# UNITED STATES PATENT AND TRADEMARK OFFICE

09/830,030

<b>Office Action Summary</b>	<b>Application No.</b> 09/830,030	<b>Applicant(s)</b> ICHIKAWA ET AL.	
	<b>Examiner</b> JENNIFER A. LEUNG	<b>Art Unit</b> 1797

## **DETAILED ACTION**

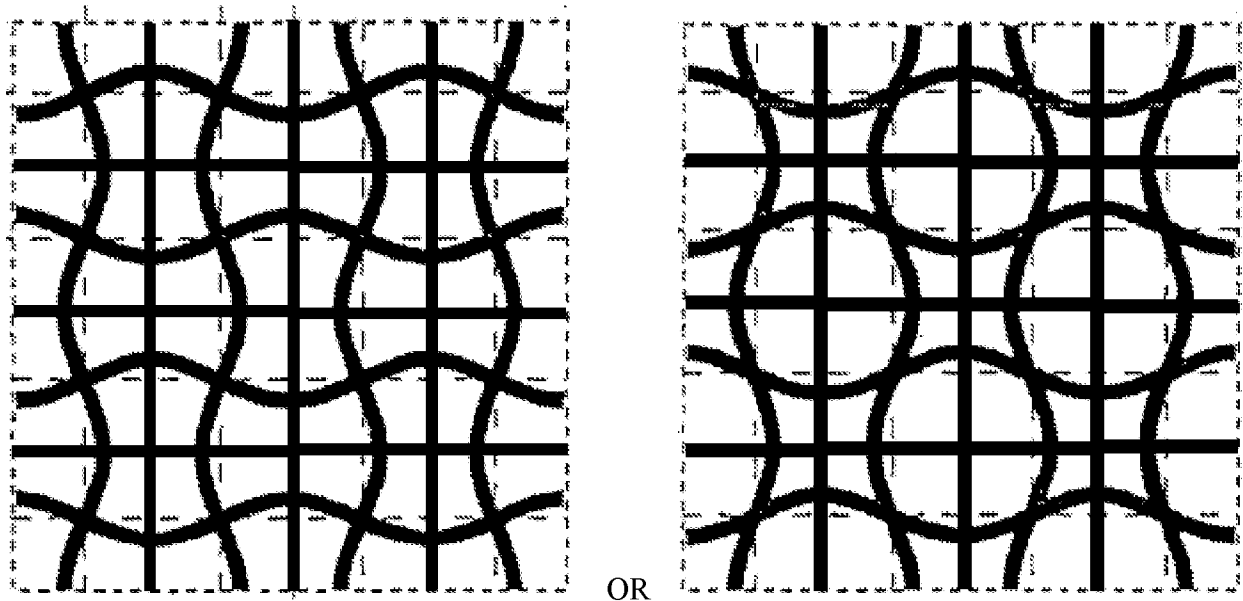
Secondly, the Examiner maintains that the honeycomb structures shown in FIGs. 3 and 4 (in the X-Y plane) would not produce the Y-Z plane illustrated in FIG. 28B, in which each recession faces an opposite recession, and each protrusion faces an opposite protrusion, with the flat wall therebetween. In fact, the honeycomb structures shown in FIGs. 3 and 4 would both produce the Y-Z plane illustrated in FIG. 28A. In order for the Y-Z plane in FIG. 28B to occur, the corresponding X-Y plane of the honeycomb structure would have to look like, for example,

However, neither of the above illustrated configurations is supported by the original disclosure.

FIG. 28B and its description thus constitute new matter.
